**ROLL-ON/ROLL-OFF BERTH
PORT OF UMM QASR, IRAQ**

SUSTAINMENT ASSESSMENT

**SIGIR PA-08-162
JULY 8, 2009**

SUBJECT: Report on Roll-On/Roll-Off Berth, Port of Umm Qasr, Iraq
(SIGIR Report Number PA-08-162)

Figure 2. RORO Berth 22 overview (Courtesy of GRS)

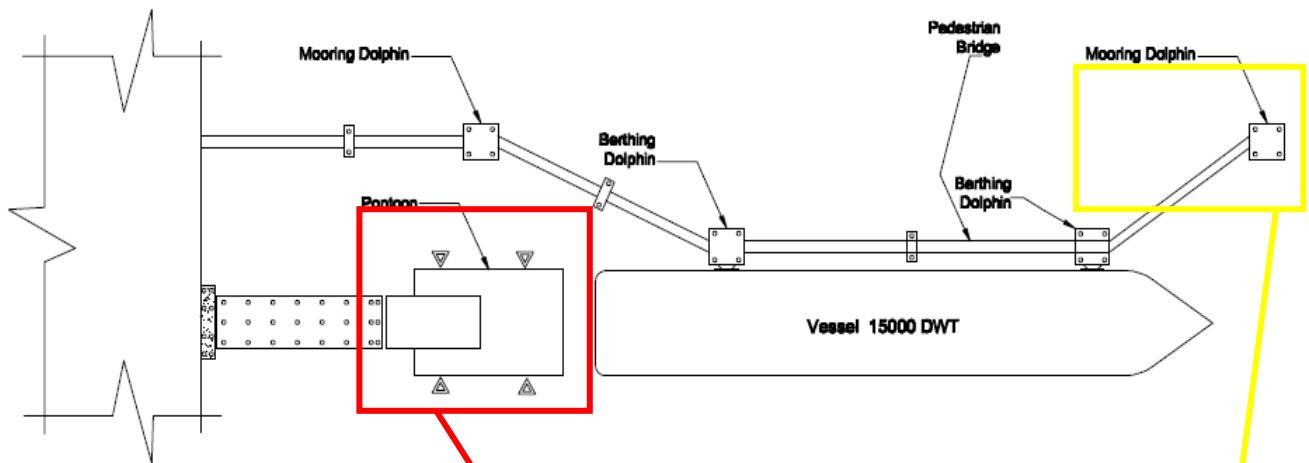
Figure 2 provides the design of the RORO Berth 22 project—a steel deck structure fixed to a concrete abutment and supported by piling. A pontoon is attached to the deck structure by a hinge mechanism, which can raise and lower according to the water level in the port (Site Photo 10). The pontoon has a steel deck structure, which allows ships to back up to the pontoon and load and unload cargo—rather than using a crane. This method of unloading is efficient for vehicles, passengers, and palletized cargo. The pontoon is affixed to four guide rail/roller assemblies, which allow the pontoon to raise and lower with the tide, but not to move laterally due to waves or ship movement.

Adjacent to the unloading deck, a steel walkway bridge connects the mooring and berthing dolphins to the shoreline sidewalk and parking area. The berthing dolphins and attached fenders allow for the absorption of some of the berthing energy,¹⁰ as well as mooring of the ship. Mooring dolphins allow for secure mooring of the ship while loading and unloading. The pontoon is also affixed with rubber fenders to absorb the berthing energy.

Figure 3. Rails/rollers - enlarged (Courtesy of the USACE)

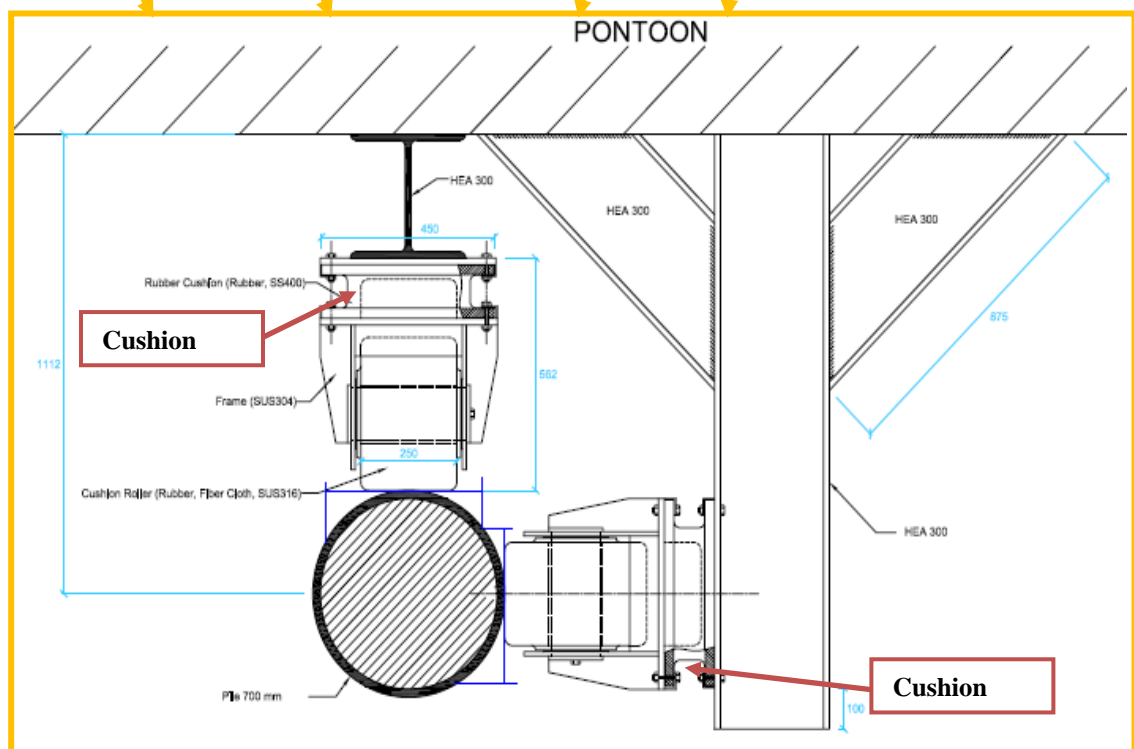
Originally, the contractor designed the cushion roller assemblies with flexible elastomeric mounts (cushions) (Figure 3). The mounts permit relative movement of the rollers and prevent binding on the vertical tracks caused by irregularities in the roller system geometry.

The contractor installed the cushion rollers with steel spacer plates over the elastomeric mounts (Site Photo 11). The purpose of the steel spacer plates is unknown; however, the steel spacer plates effectively negate any cushioning effect between the roller and the mounts. Without some flexibility of the roller assembly, any irregularity in the roller system geometry would increase the axial load and possibly bind the roller assembly.

If the roller assemblies become bound within the tracks, the steel cantilevers supporting the assemblies will be subject to torsion forces from the pontoon. Apparently, this has

occurred: the damaged steel cantilevers exhibit textbook torsion failure of a steel wide flange section with transverse tearing of the flange (Site Photo 12).

It does not appear that the original design intended for the steel cantilevers to resist torsional loading; nevertheless, because of the configuration of the cushion roller assembly, this should have been considered as a possibility. The wide flange shapes used in the design have minimal torsional capacity, which would make them an inappropriate selection. A better design would utilize a section with increased torsional resistance, such as a round or square tube section.

To ensure the continued operation of Roll-On/Roll-Off Berth 22, SIGIR recommends that the U.S. Embassy Transportation Attaché communicate to the Iraqi Ministry of Transportation the need to repair or replace:

1. Pontoon guide rail and roller assemblies
2. Hinges that connect the steel structure decking and the pontoon decking
3. Two rubber fenders on the berthing dolphins

Site Photos 15 and 16. RORO Berth 22 sheared rubber fenders

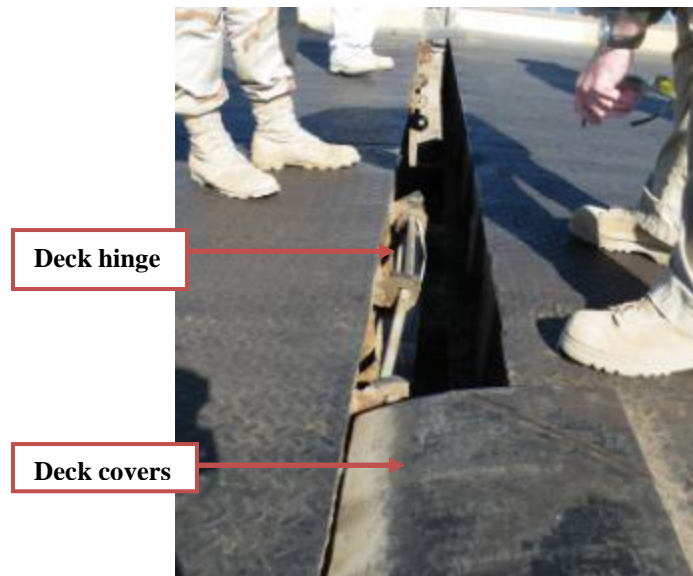
The design showed that RORO Berth 22 fenders were 600 mm high and 1150 mm long. At the time of the inspection, one of the rubber fenders on the first berthing dolphin had been severely damaged. The rubber fender appeared to be sheared off (Site Photos 15 and 16). The specific cause of the damage could not be determined; however, GRS personnel stated that the damage was caused by careless/rough operations by port personnel. In SIGIR's opinion, the damage was probably caused by ships approaching the dolphin too fast or poor mooring during storms. The damage will not have a significant impact on the operations of the facility; SIGIR considers this a minor maintenance issue.
